## **ACP-2021-078 ENABLING REMOTELY PILOTED AIRCRAFT SYSTEM OPERATIONS FROM RAF FAIRFORD – HALE**

1. This is the formal response to the request for Post Implementation Review (PIR) Data requirements for ACP-2021-078. On 16 February 2024, the EGD218 complex was approved for notification pending the satisfaction of several conditions for use. Those conditions were met, allowing for the first two activations to occur on 22 and 24 August 2024.
2. After CAA approval of ACP-2021-078, Birmingham Airport identified impacts to civil air traffic in and out of Birmingham Airport. Several meetings were conducted to assess the impacts and discuss possible mitigations. As a result of these meetings, on 6 August 2024, the CAA imposed additional conditions on the approval of ACP-2021-078 requiring the Sponsor to conduct an early PIR. This PIR was to focus on impacts to Birmingham Airport operations during the first two planned activations on 22 and 24 August 2024.

### **ACP-2021-078 Post Implementation Review**

Initial ~35 mins of 24 August departure profile

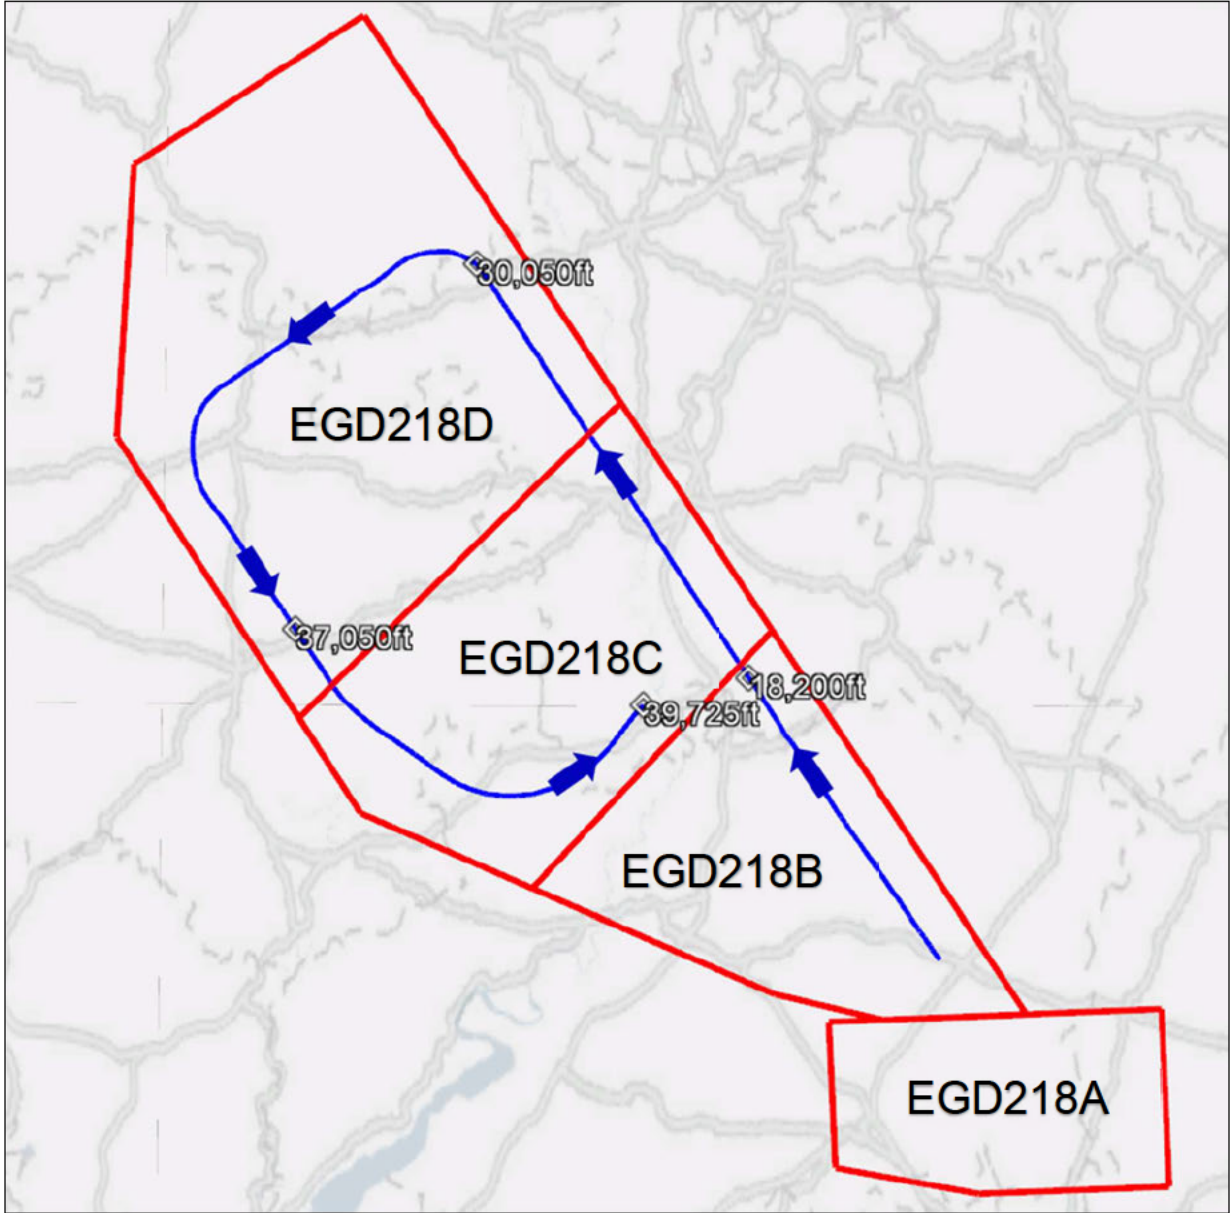
20. Allowing for a SUACS when civil traffic and the HALE RPA are separated sufficiently by altitude would eliminate even more impacts. For departure activations, the impact could be limited to the first 30 minutes after the HALE RPA departure. Due to the standardized and highly predictable departure profile of HALE RPA, only the initial transit of EGD218C occurs within the lower portion of that airspace. Subsequent transits will be a much higher altitude across EGD218C and EGD218D. On the 24 Aug departure, the HALE RPA was above FL370 before entering EGD218C for the second time enroute to FL500. If procedures allowed for a SUACS for civil aircraft, the HALE RPA would be separated from most Birmingham Airport arrivals by ~20,000 feet or more vertically in all but the first ~30 minutes of the initial climb.

**ANNEX A – COTSWOLD FUA/CTA AIP CHART**

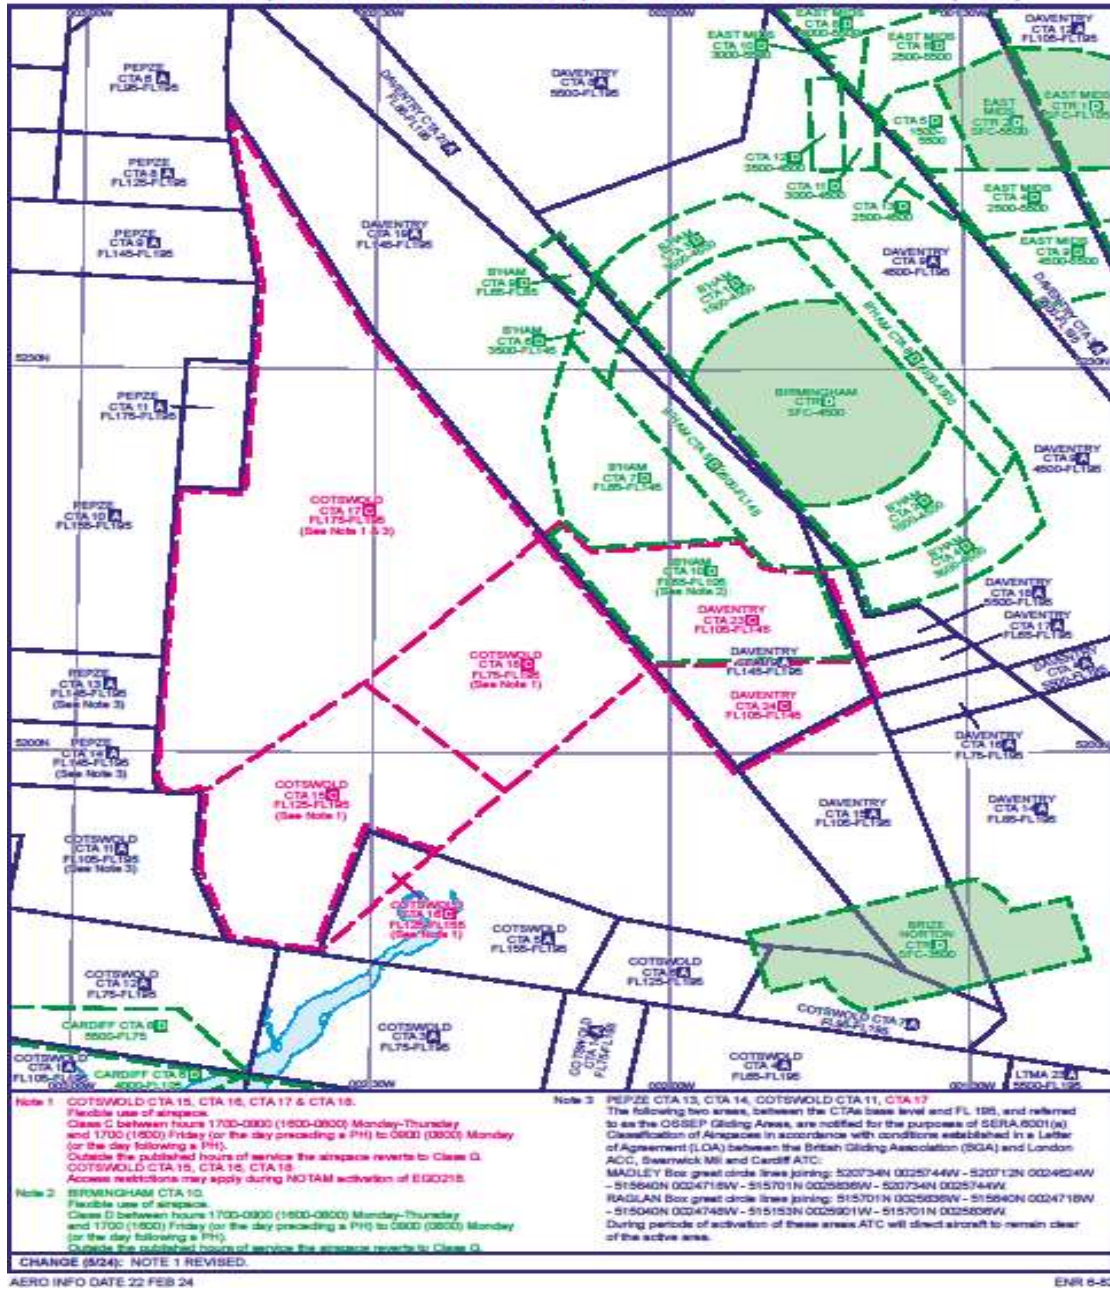
A number of online meetings have been held to determine a potential way ahead, with both Birmingham Airport and NATS En-Route procedures working to identify potential solutions to allow the continued use of the Cotswold FUA during EGD218A-D activations. For clarity, the only portion of the EGD218 complex that directly impinges on the Cotswold FUA, is EGD218C.

Of the solutions being suggested, two are by far the best options available to permit the continued use of the Cotswold FUA, without major impact on the EGD218C operations. They are:

1. The NATS En-Route Procedures staff indicated there was scope to adjust the base level of EGD218C (FL160-FL660), from FL160 to FL180 and maintain existing FUA procedures.

Given the overlapping levels of EGD218B (FL50-FL240) & D (FL200-FL660), there is absolutely no operational impact on the RAF Fairford RPAS operation as climb and descent profiles can easily be achieved even with the proposed revised base level of EGD218C.

2. Under-flying EGD218C, below the current defined base level of FL160, but within the existing levels of the Cotswold FUA.

11. Birmingham Airport offered two possible solutions during engagement feedback. The first is to raise the floor of EGD218C to FL180. The second solution is to permit under-flying EGD218C, below the current defined base level of FL160, but within the existing levels of the Cotswold FUA.

12. USAFE is unable to accept raising the floor of EGD218C to FL180 as it would not ensure departing HALE RPA can reliably remain within the danger area and in compliance with the safety buffer for this airspace. In the first departure, the HALE RPA reached FL180 approximately 1 NM from the boundary of EGD218C. Additional fuel load, temperature, or winds may impact climb performance such that achieving FL180 by EGD218C cannot be ensured without modification of EGD218B and/or EGD218A to allow for sufficient volume and/or altitude for additional climb prior to the boundary of EGD218C. During engagement with NATS for ACP-2021-078, a ceiling of greater than FL075 in EGD218A or increased lateral volume of EGD218B was expected to create significant impacts to civil air traffic. Changing the dimensions of EGD218A and EGD218B to allow for a higher floor in EGD218C would

14. The Sponsor has no objections to Birmingham Airport's second solution to allow for under-flying of EGD218C. During engagement, NATS shared concerns with this solution due to adjacent airspace delegated to Cardiff.
